MONITORING YEAR 0 ANNUAL REPORT FINAL

CARPENTER BOTTOM MITIGATION SITE

RE: Carpenter Bottom Draft MYO Report Review
Catawba River Basin - CU# 03050102
Gaston County
DMS Project ID No. 100090
Contract #7731

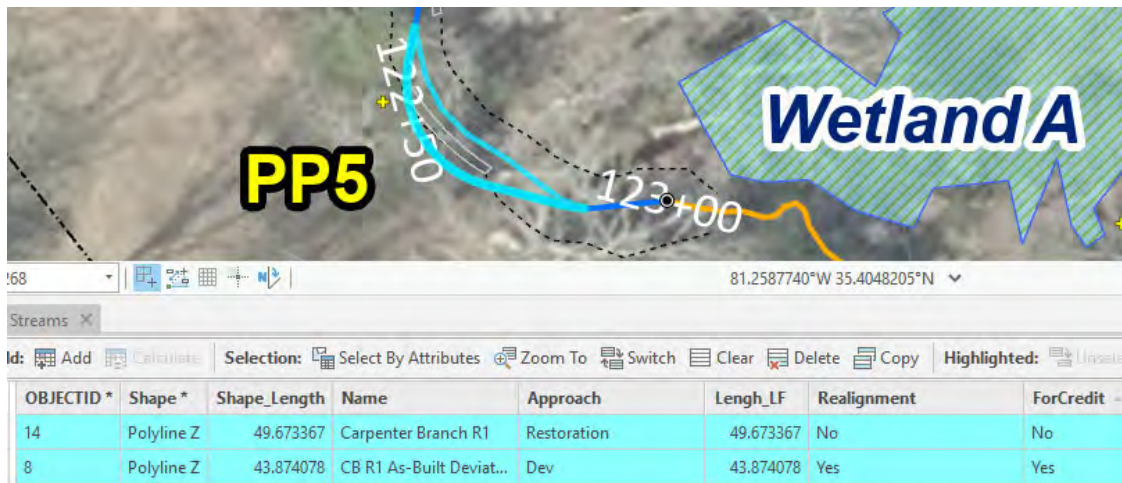
DMS' Comment: XS 2,3 and 6 photos appear to show riffles with very little to no flow on the surface. Does WEI have concerns regarding the depth of riffle material and the ability to achieve surface flow over these areas?

Wildlands' response: Wildlands does not have concerns about the stream's ability to achieve surface flow over the upstream extent of Carpenter Branch Reach 1. Cross section 2 is on an intermittent reach, so it is not surprising that the reach is dry in the September photos. Cross sections 3 and 6 both show some staining on the rocks indicating that flow has occurred over the riffles. It is expected that once the stream

has time to stabilize and the riffle material settles, winter rain will recharge the streams and flow will return as shown in the photos taken in February at PP1 and PP2.

STA: 122+32 - 122+95
OPEN AREA BUFFER PLANTING CHANGED
TO RIPARIAN CORRIDOR PLANTING DUE
TO CHANNEL REALIGNMENT.

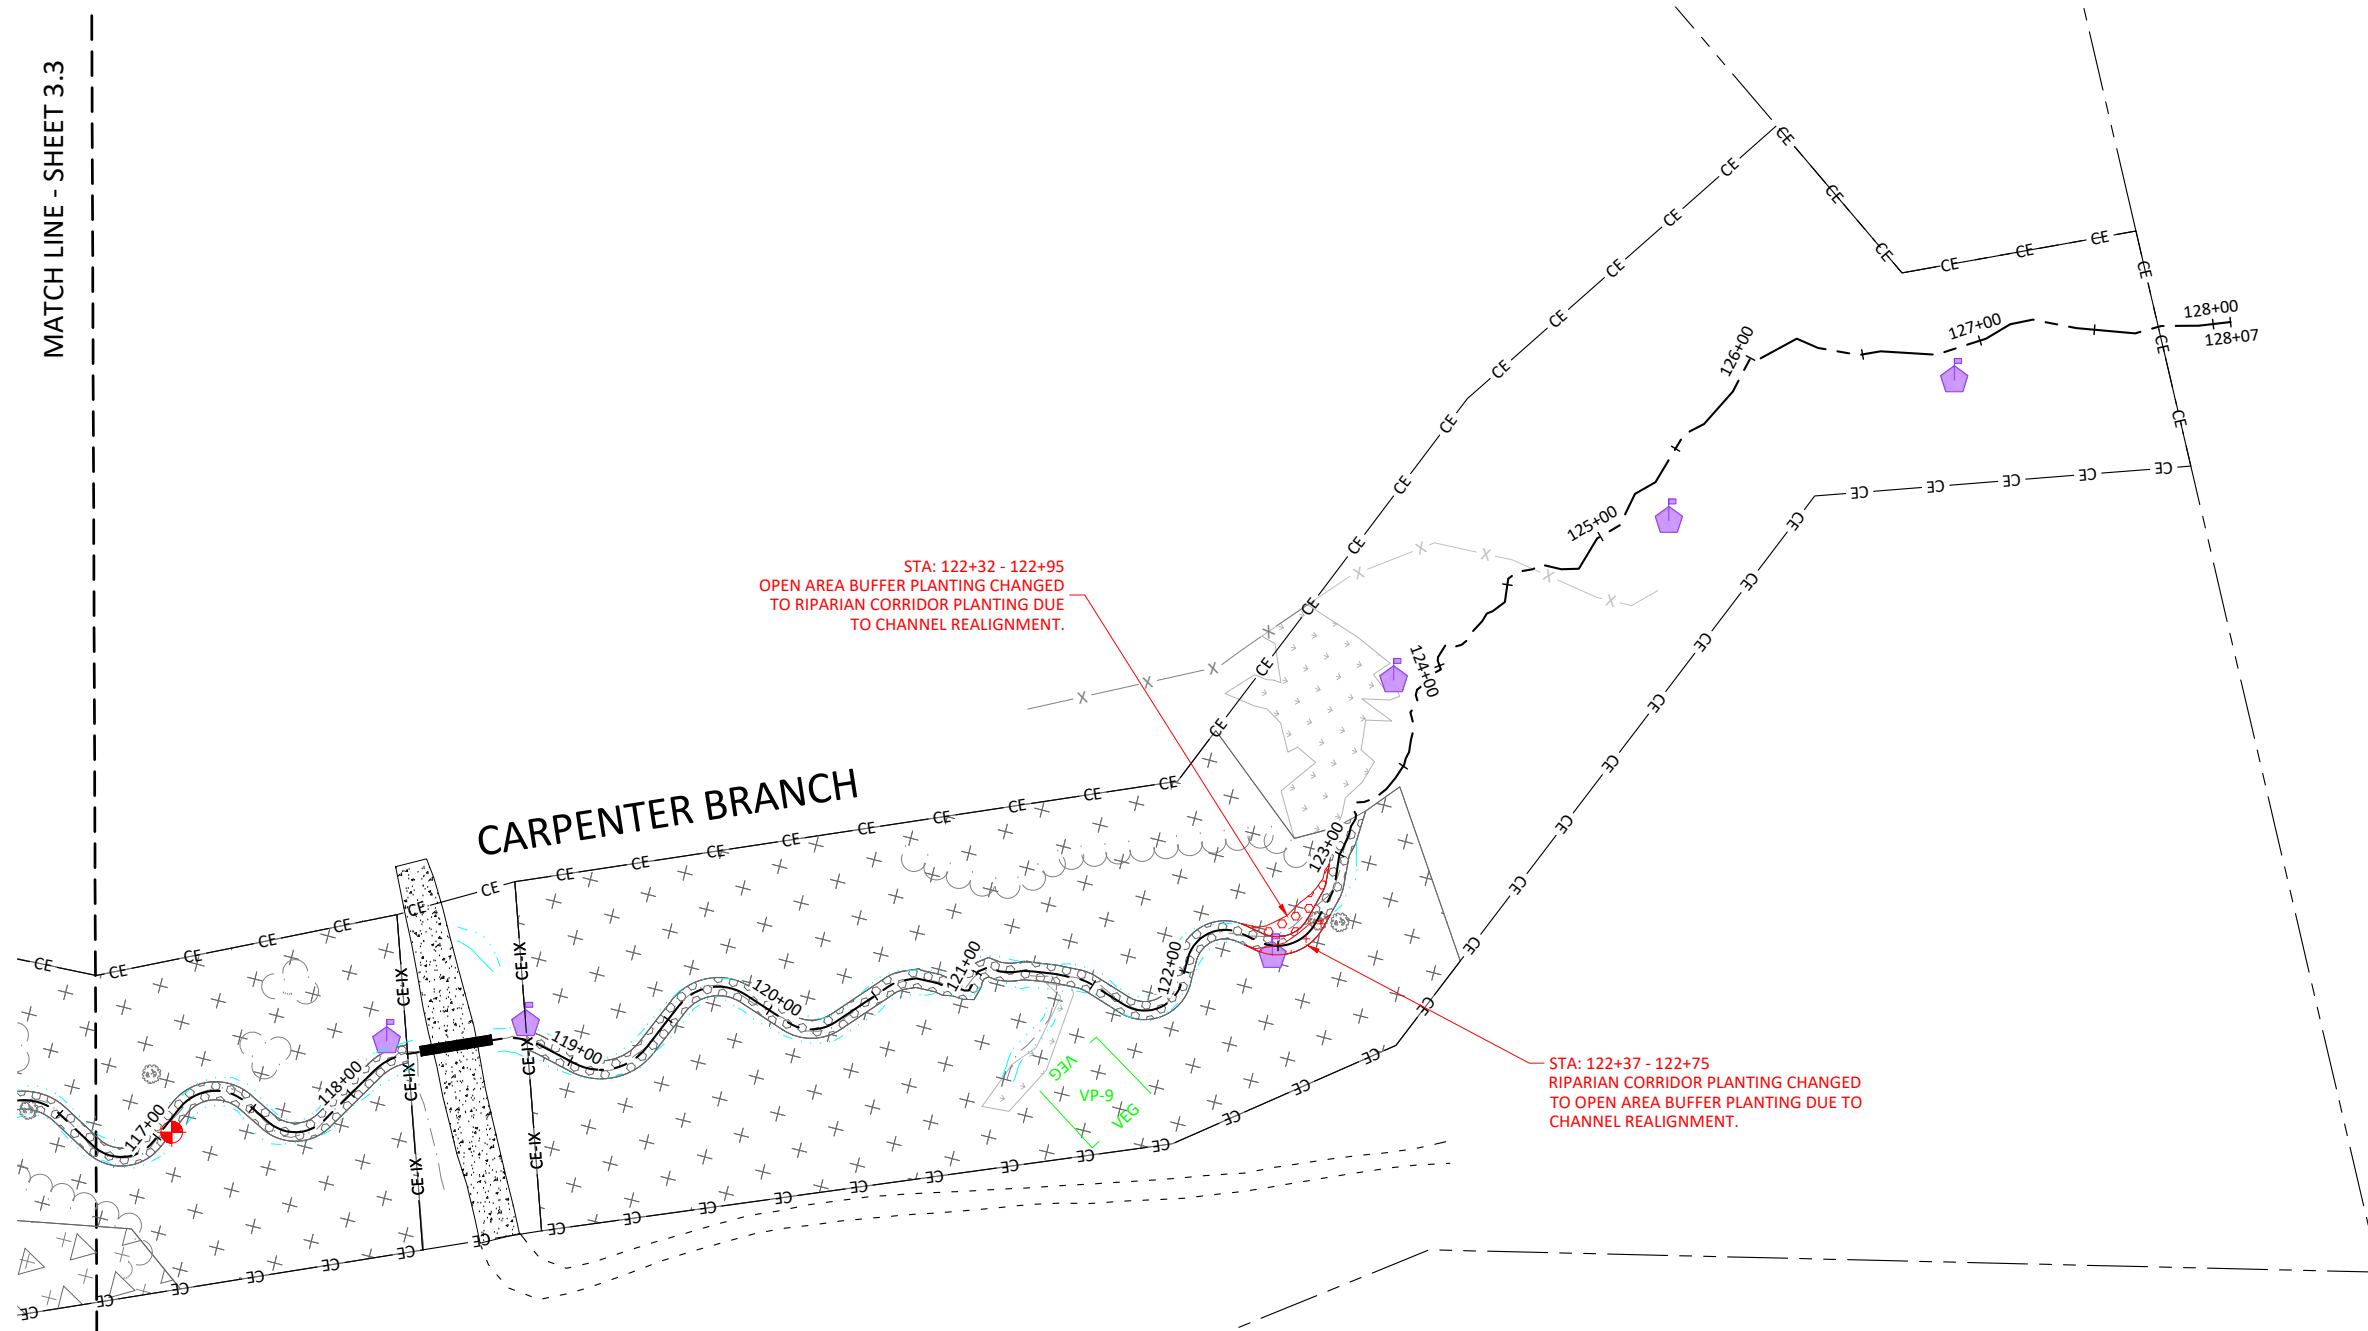
DMS' Comment: Sta: 122+39 – 122+84 note specifies 38 linear feet are realigned. Redline drawing says 44'. Please review and update as necessary for consistency.

Wildlands' response: The STA 122+39 – 122+84 note was revised, in the report and on the record drawings, for clarification. The stationing listed represents where the channel realignment deviates from the design; however, the actual channel realignment resulted in 38 linear feet, for a loss of 6 linear feet.
